Q&A

VRC 2022-2023: Spin Up

Tagged: Field Specifications

Figure 3: The Driver Station configuration for VIQC Slapshot.

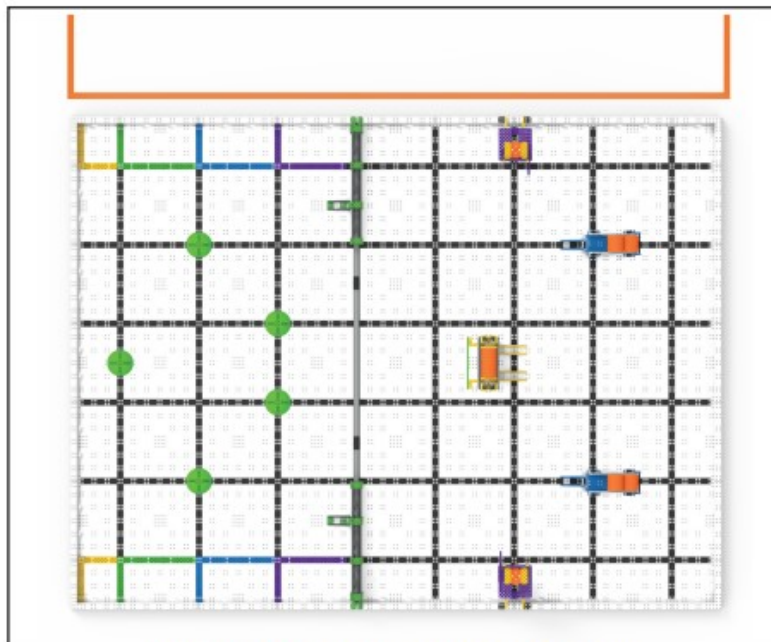
Hi, Just checking on the driver station. Is the driver station on either side of the field along the 8ft and if so do both teams have to be on the one side or can the teams split to one per side? Or is it exactly as shown in the game manual being one specific side?

The Driver Station indicated in Figure 3 of the Slapshot game manual identifies the region where Drivers **must** remain during the Match unless legally interacting with the Field. From the Drivers' perspective, the Dispensers should always be on the left portion of the Field, and the Goal Zones should be to the right.

There are no alternate Driver Station configurations for VIQC Slapshot.

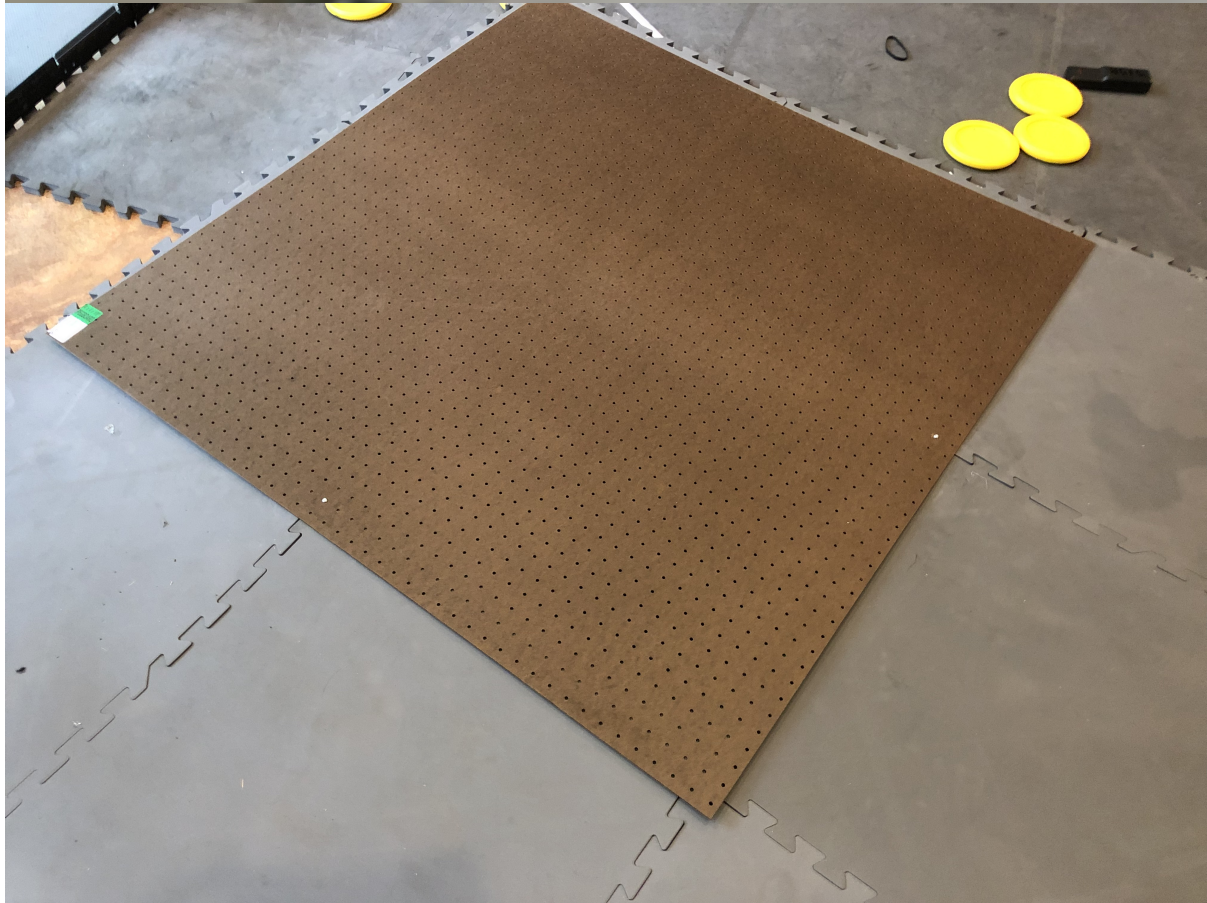
The red and blue barrier assemblies are ripping field tiles within an hour of light practice. See the images below for examples. Our EEM advised us to pose this question on this Q&A.

"Light practice" to our team means that we have driven the robot at a slow speed and, as such, has contacted the barrier at a slow speed. That contact with the barrier causes the barrier to gradually move and rip the field tile. Continued contact in this manner results in rips of 6-8 inches after a few interactions with the barrier. We have talked with other teams who are experiencing the same. Two of the images below are ours and one is from another team.

There are two issues with ripped tiles: 1.) the cost to replace them (\$250 for a set), and 2.) the barriers no longer stay in place which results in field barriers (far) outside of their normal ± 1 " tolerances, according to <T25> of 2022 – 2023 Game Manual Version 1.0, which states "Be prepared for minor field variance. Field Element tolerances may vary from nominal by ± 1.0 ..."

Appendix A in the August 2 Game Manual update included an approved modification to the Spin Up field to solve this problem.

A small circle base plate can be added to the center hole of each Low Goal to provide additional support.

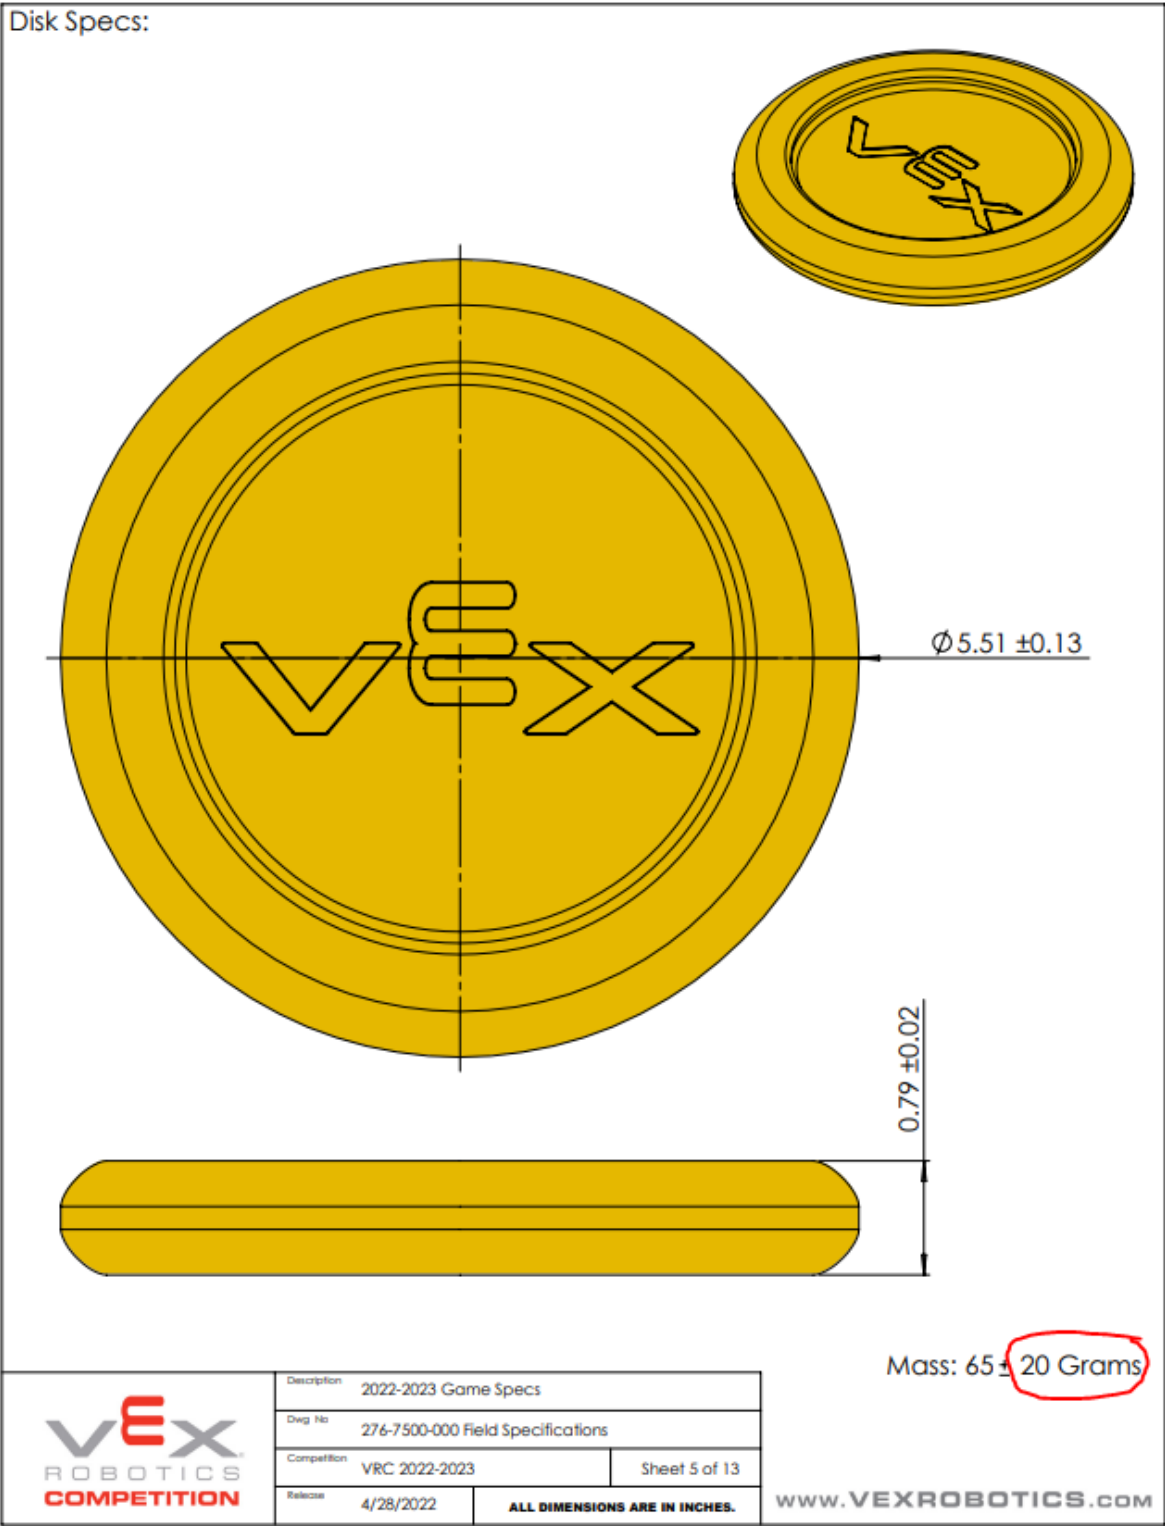
Appendix A on page A-9 of the Game manual states that the mass of a Disc is 65 grams, ± 20 grams (see attached picture)

Thank you for bringing this to our attention. The correct tolerance is +/- 20 grams. This will be corrected in the June 14th Game Manual update.
